<b><i>MaSPR-24-30</i></b>	<b><i>Staff Report – August 19, 2024</i></b>
<b><i>Application Type:</i></b>	Major Site Plan Review Application
<b><i>Project Address:</i></b>	1153 W Fayette Street (Tax Map #099.-03.3-03.2)
<b><i>Summary of Proposed Action:</i></b>	A Major Site Plan Review to convert the land use from a former 6-story commercial building into a Public Safety Building land use type with an accessory parking lot.
<b><i>Owner/Applicant</i></b>	1153 Owner, LLC. (Owner/applicant)
<b><i>Existing Zone District:</i></b>	Mixed-Use Transition, MX-3 Zone District
<b><i>Surrounding Zone Districts:</i></b>	The neighboring properties to the north are within the Light Industry and Employment, IN Zone District, to the east are within the MX-3 Zone District, and to the west and south are within the Urban Core, MX-4 Zone District.
<b><i>Companion Application(s)</i></b>	None
<b><i>Scope of Work:</i></b>	The scope of work includes partial demolition of the single-story portions of the buildings, exterior façade improvements to the building, major interior renovations for offices and operational space for Syracuse Police and Fire Departments, and site improvements for a new parking lot, new s

Drawing No.:  
**C-100**

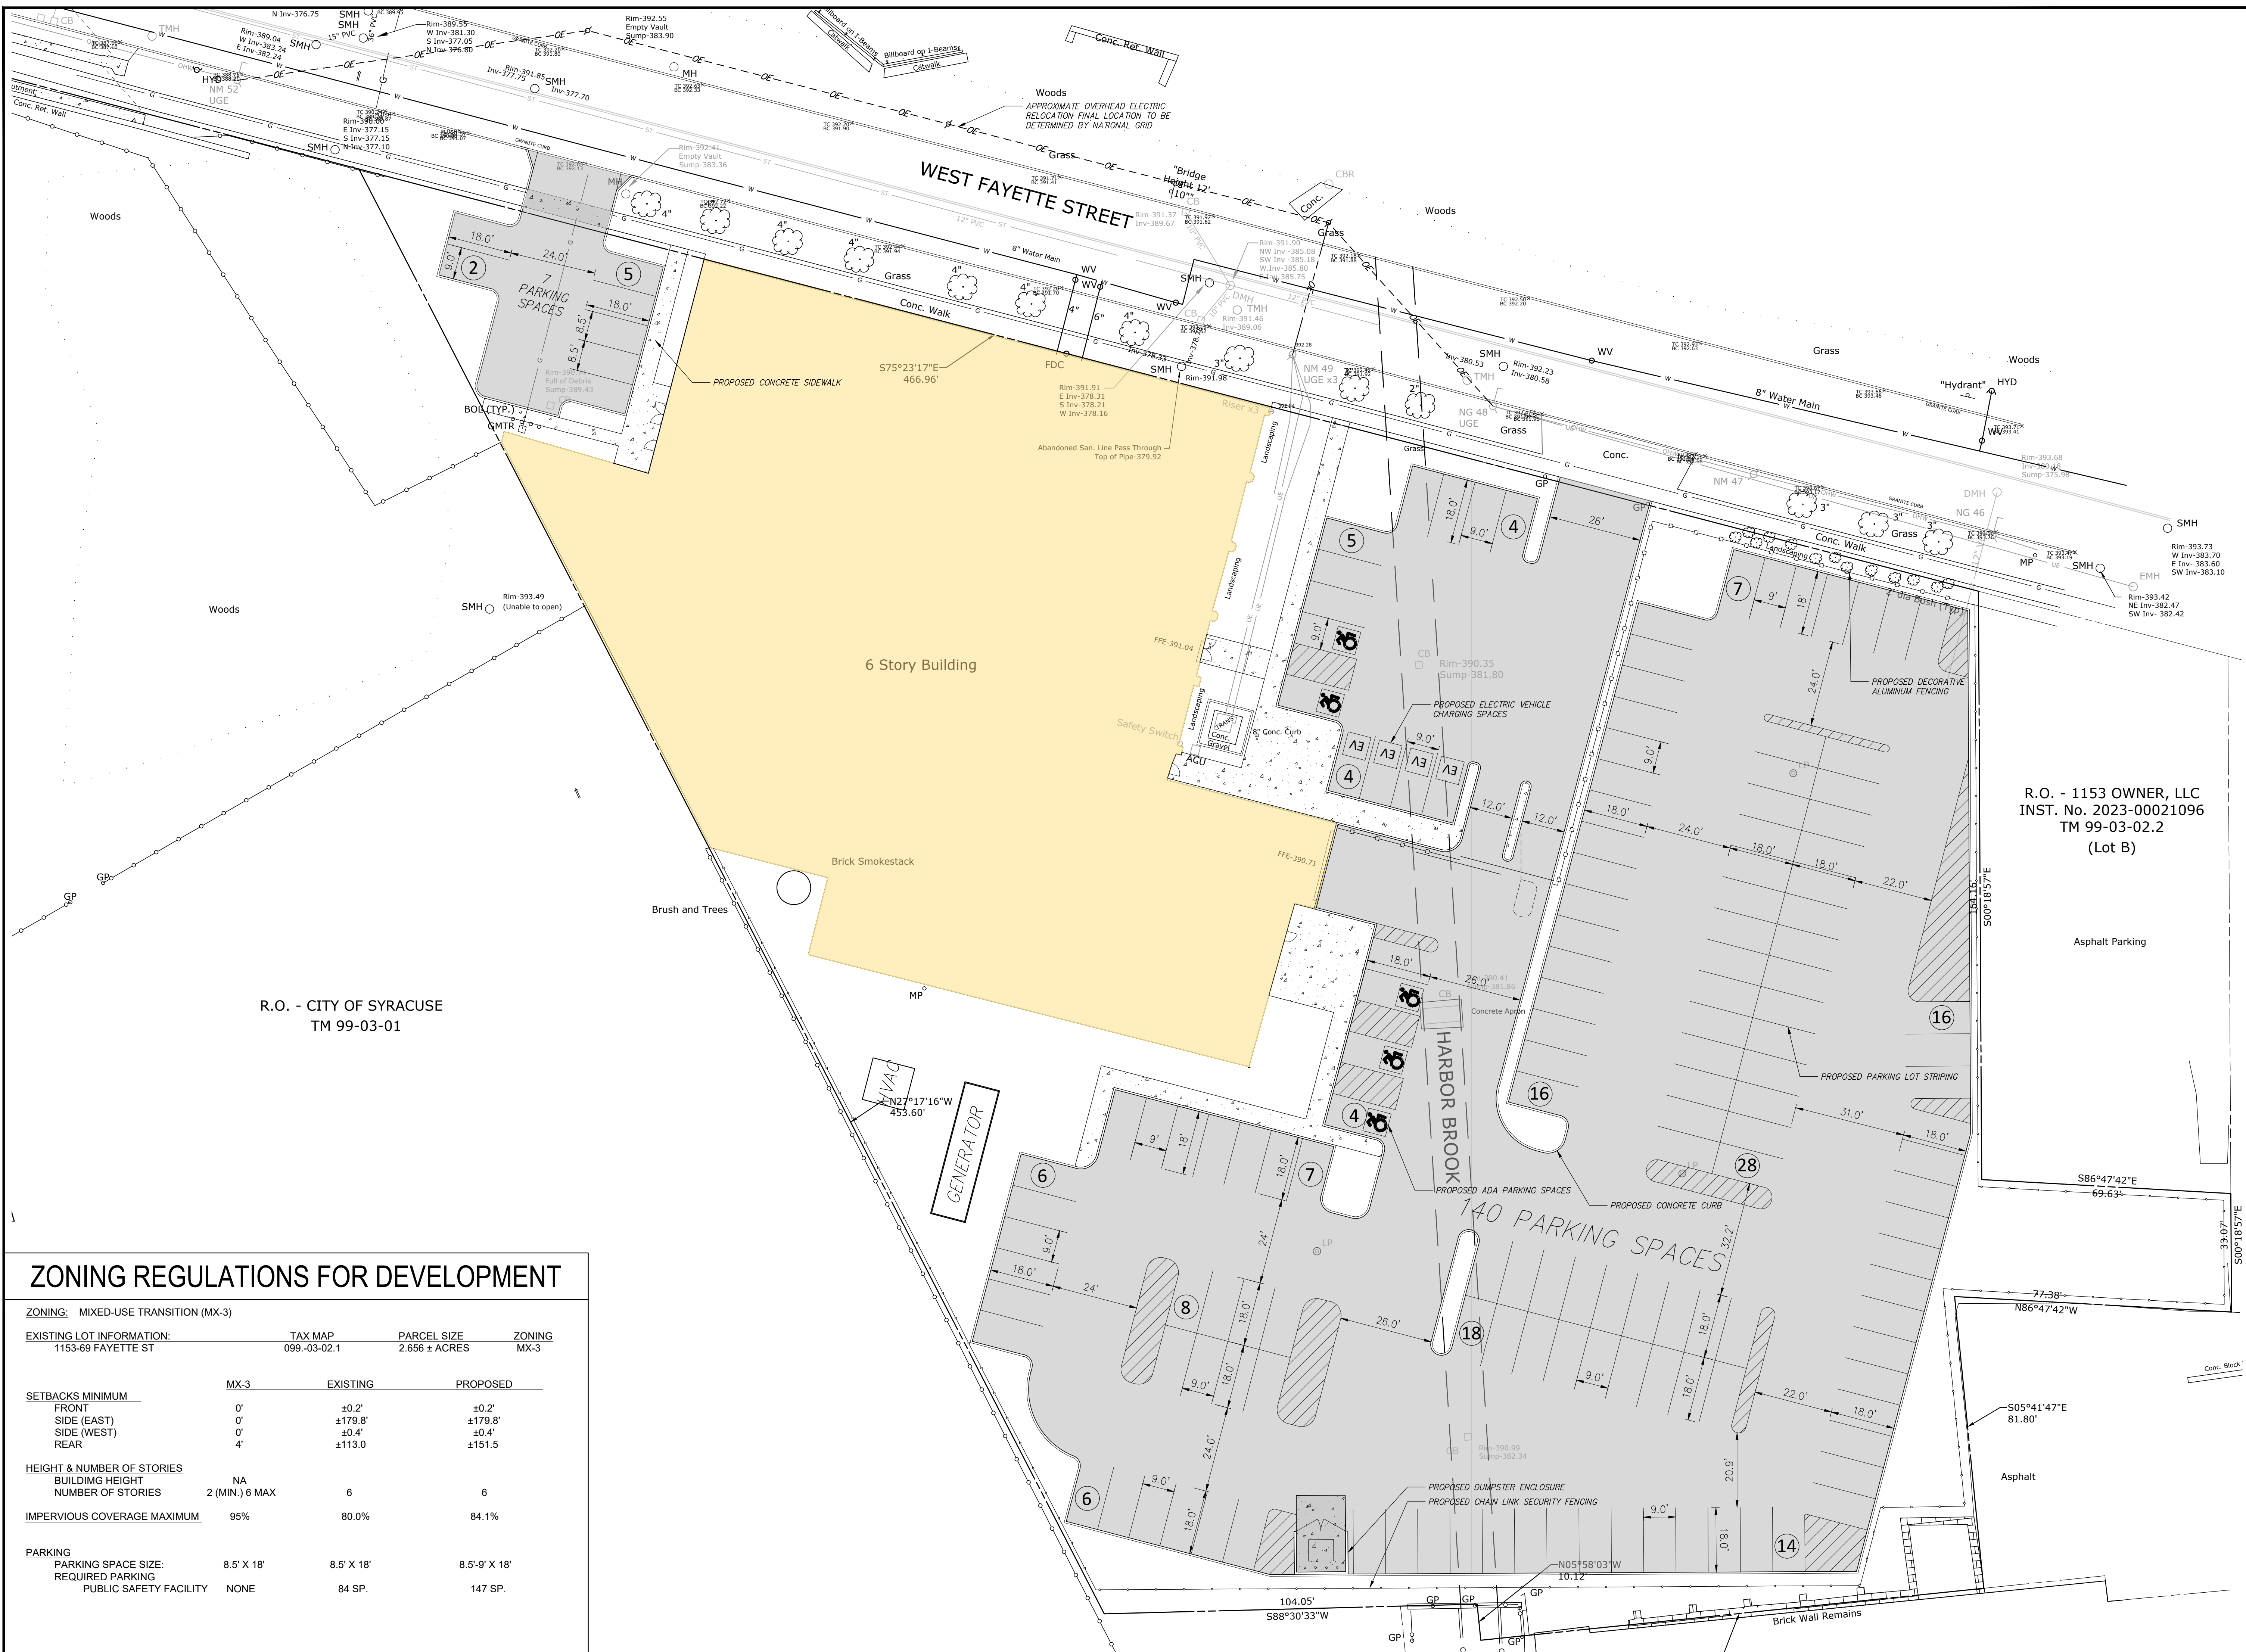
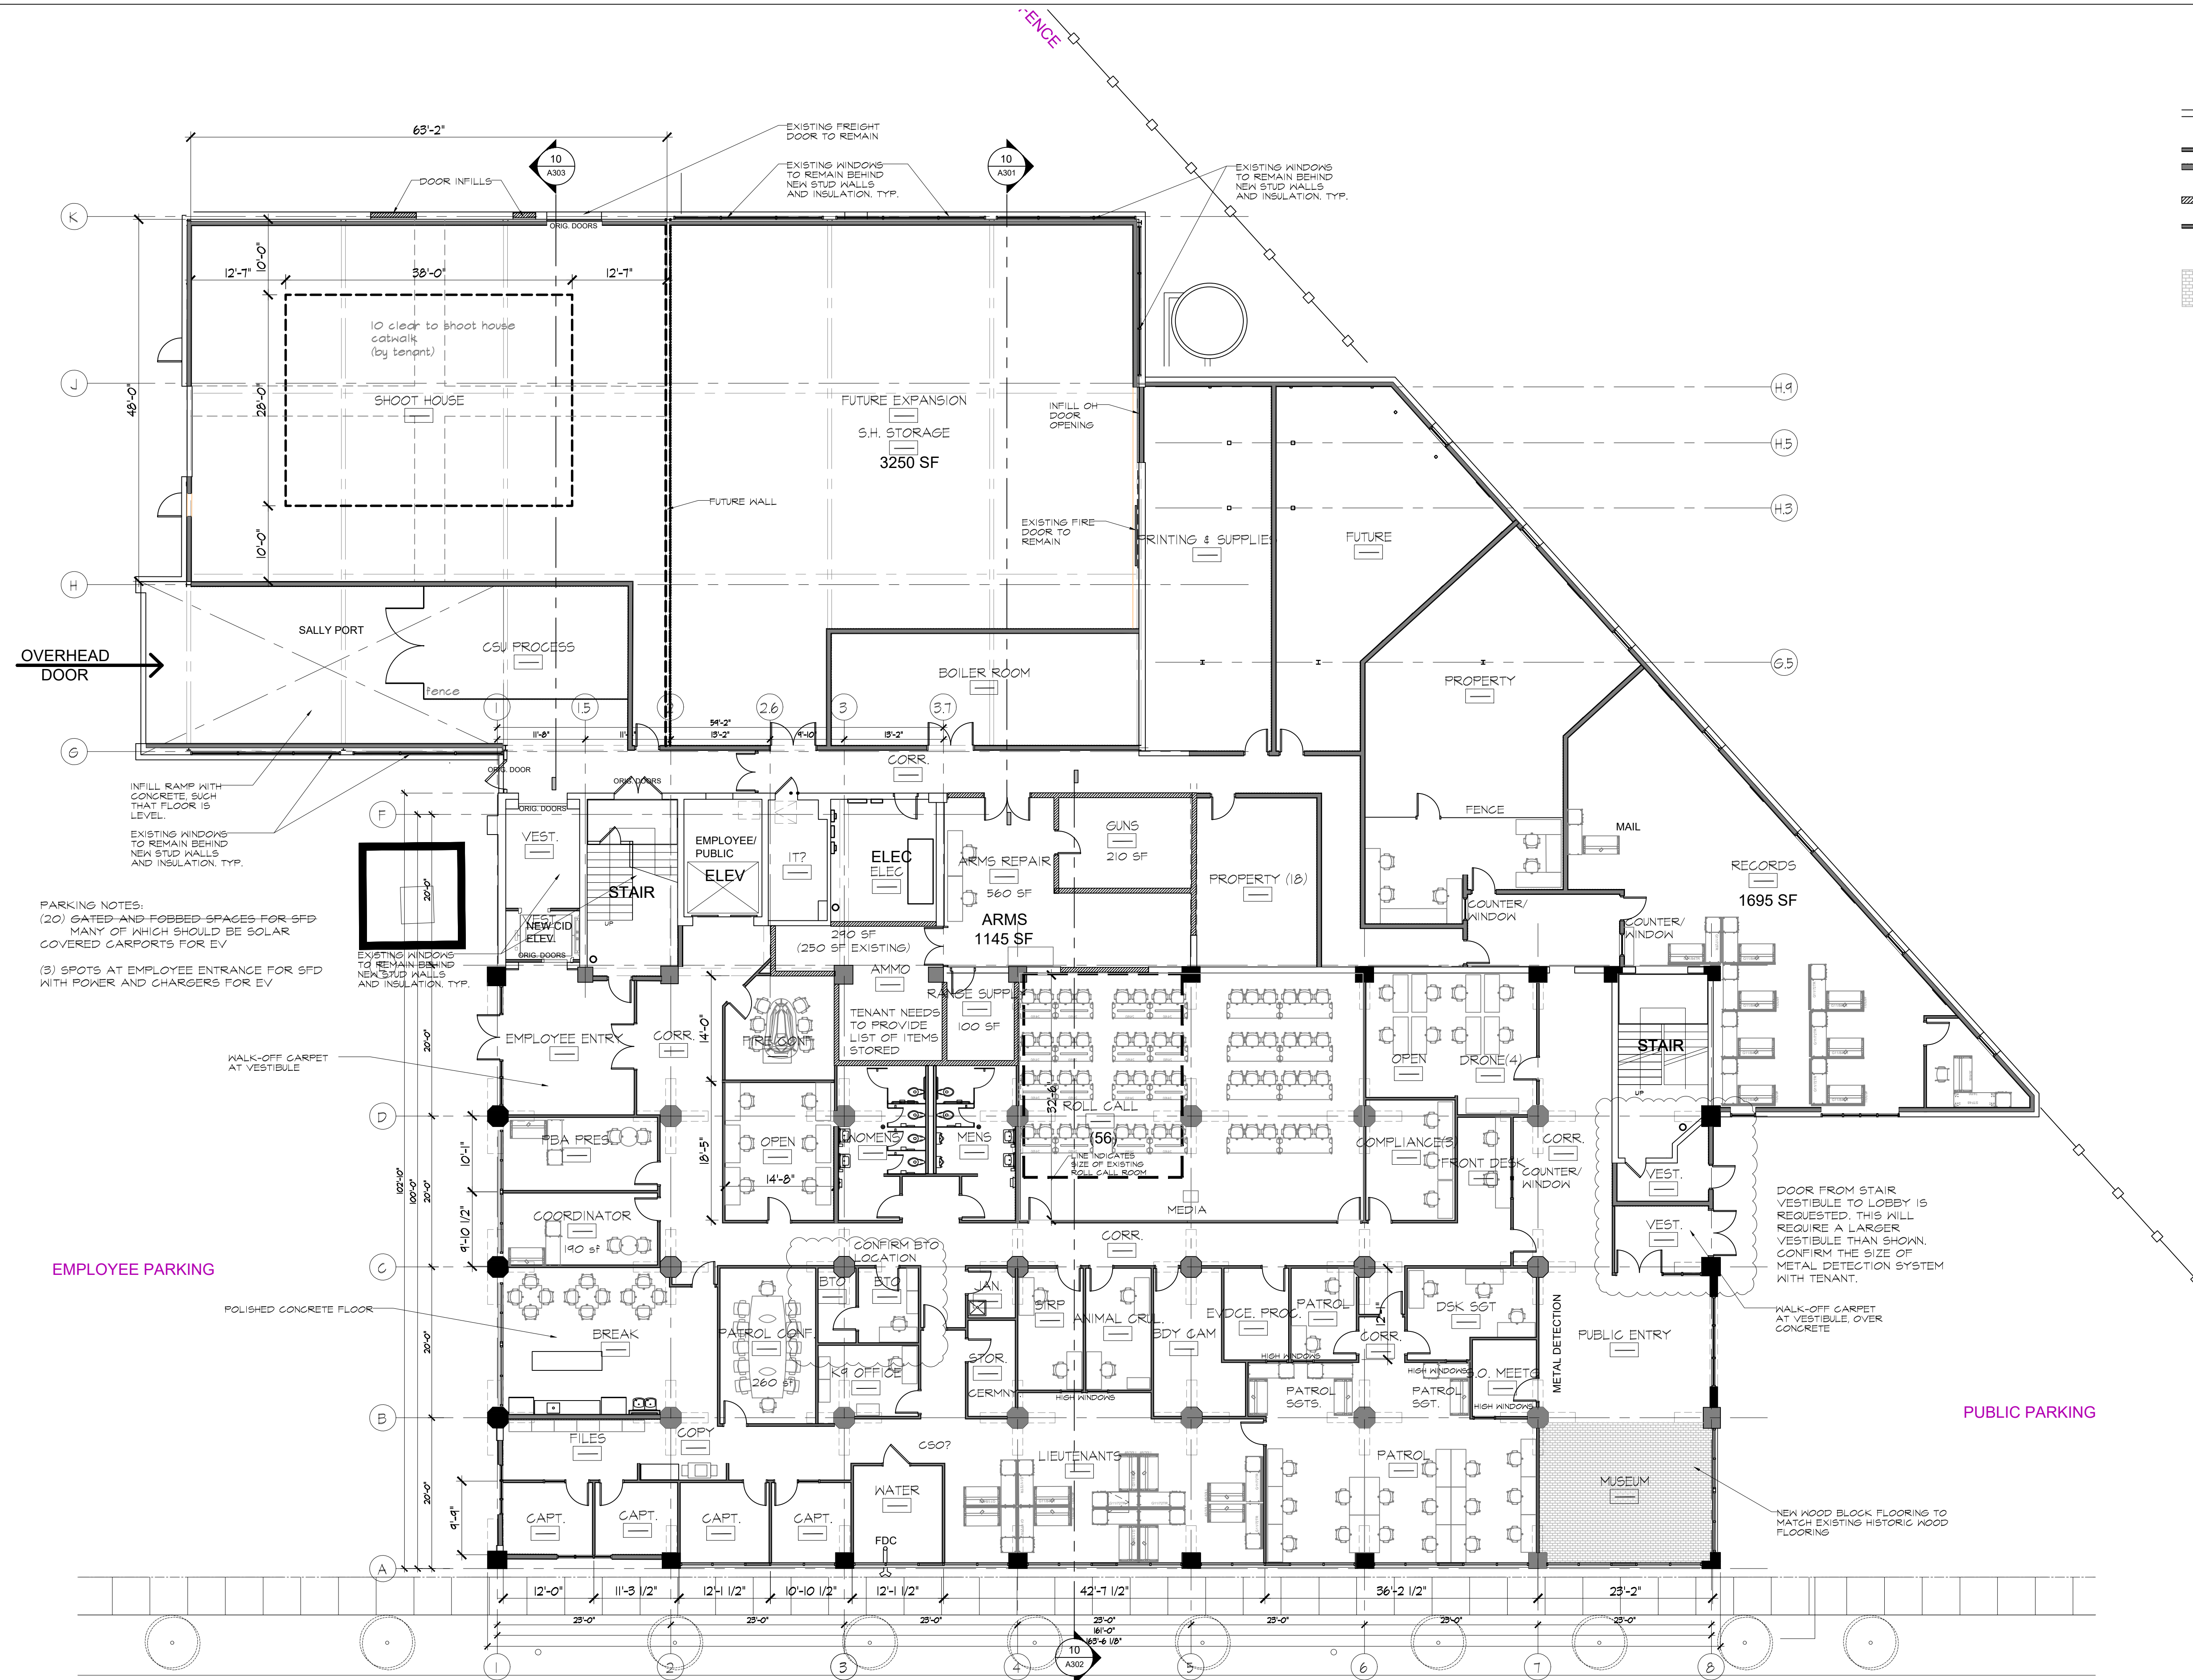
WHEREAS, per the Site Layout Plan dated 6/18/24, the existing parking lot will be renovated, possibly removing some asphalt, but the exact amount is unclear from the Site Plan; the small northwest lot will have 7 parking spaces and a 24'-wide driveway to West Fayette Street; the large parking lot will be renovated and formalized to contain multiple sections, totaling 140 parking spaces with a 26'-wide driveway to West Fayette Street; concrete sidewalks will be installed between the building and parking lots; it is not clear from the Site Plan which specific parts of the complex will be demolished, but it appears a small portion of building at the rear of the building complex will be removed; per the Environmental Assessment Form (EAF) dated 7/1/24, the 2.90-acre site contains 2.13 acres of impervious surface and the proposal will result in an increase to 2.23 acres of impervious surface; and

WHEREAS, the referral materials do not include an existing conditions plan, detailing regarding any onsite stormwater infrastructure (existing, to be retained, or proposed), and the Site Plan does not depict whether the land not occupied by building or parking will remain asphalt or will be lawn or landscaping; a Landscaping or Planting Plan was not included, but some trees and landscaping along the road frontage are depicted; per Google Streetview, this landscaping appears to be existing; and

1. Projects within an Onondaga County Drainage District that require a Stormwater Pollution Prevention Plan (SWPPP) must submit a copy of the SWPPP to the Onondaga County Department of Water Environment Protection for review. The municipality must ensure any mitigation as may be determined by the Department is reflected on project plans prior to, or as a condition of, municipal approval.
2. The applicant must coordinate and obtain approval from the Onondaga County Department of Water Environment Protection regarding the proposed stormwater connection to the channelized portion of Harbor Brook prior to, or as a condition of, municipal approval.

3. Given the stormwater drainage concerns on site and proximity to Harbor Brook, the the applicant is encouraged to 1) retain as much existing tree cover as possible, 2) reduce impermeable surfaces, 3) utilize green infrastructure (e.g., permeable pavement), and 4) add landscaping, plantings, and trees to improve
